VALIDATION OPINION FOR THE REVISED
MONITORING PLAN:

LG Chem Naju plant fuel switching project

UNFCCC Ref. No. 2475

REPORT No. 2011-08

<Figure 1> the monitoring diagram for the project activity

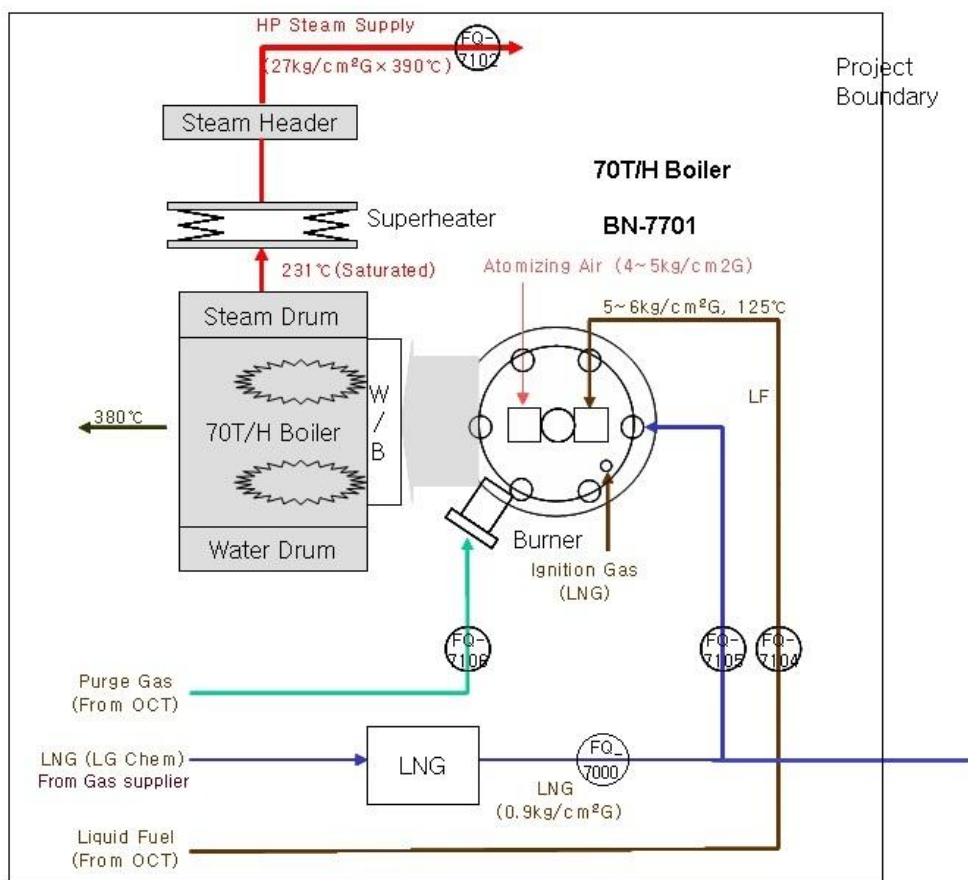
When the PDD was drawn up, fuel switched boiler of the project activity was only one natural gas consumption facility in the plant. However, after registration, PP has extended use of natural gas to other facility since December 2009 and it is branched from the natural gas pipeline (after the meter 7000). Thus, the meter 7000 measures the natural gas consumption of project activity as well as the other consumption.

Due to above reason, PP have changed monitoring point of $FF_{\text{project,y}}$ to another flow meter (Tag No. FQ_7105; hereafter called it meter 7105) located in front of the boiler for natural gas consumption in the project boiler. The meter 7105 was installed at the time of construction for project activity and PP have been measuring and recording the consumption of natural gas in the project activity. Therefore, the meter 7105 will be used instead of meter 7000 for $FF_{\text{project,y}}$. (Refer to Figure 1).

Meter 7000 and 7105 have same level of accuracy to measure natural gas consumption as shown in the table 1 below. Hence, the validation team could conclude that the change from meter 7000 to meter 7105 does not reduce the accuracy of emission reduction calculation.

The validation team confirms that the revised monitoring plan to determine the consumption of natural gas is appropriate and valid for calculating emission reduction and the level of accuracy or completeness in the monitoring and verification process is not reduced as a result of the revision and it is still in accordance with the approved monitoring methodology. And also the corrective action for erroneous measurement or malfunction is valid and reasonable.
